HOMESTEAD NORTH PHASE I PRELIMINARY PLAN

this is a rezone (map
amendment
application)

LETTER OF INTENT

NOVEMBER, 2020

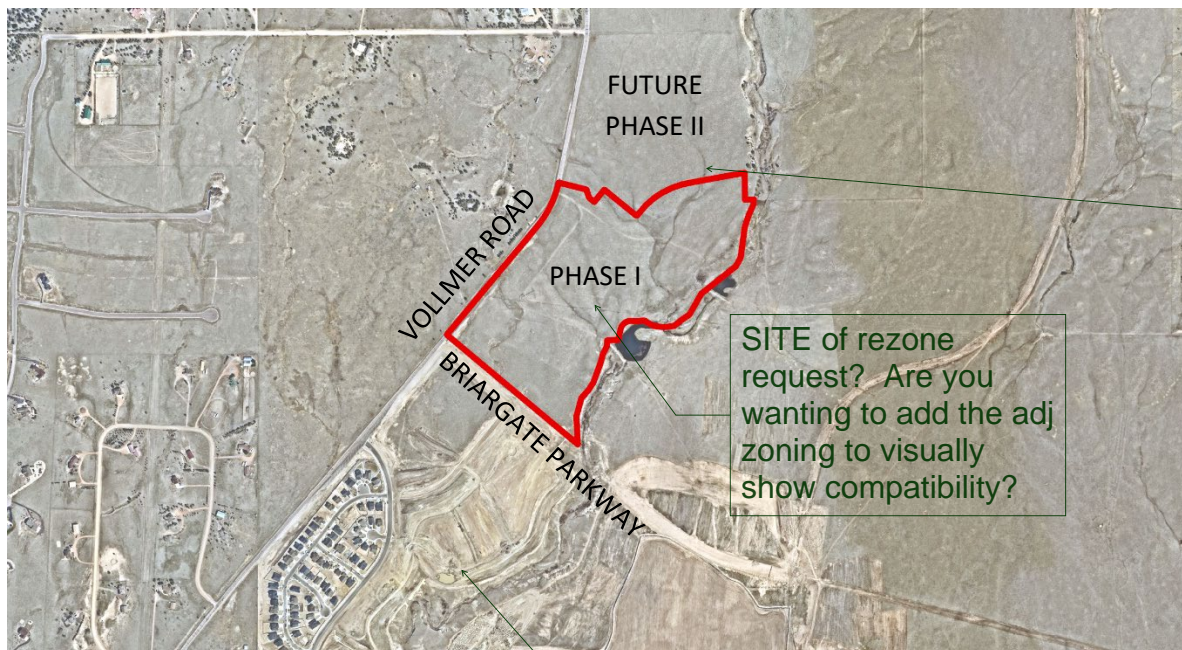
SITE of rezone
request? Are you
wanting to add the adj
zoning to visually
show compatibility?

Im not
sure what
this map is
trying to
convey in
relation to
a rezone
request.

Im not sure what this map is trying to convey in relation to a rezone request.

SITE of rezone request? Are you wanting to add the adj zoning to visually show compatibility?

I would use an updated map that shows development
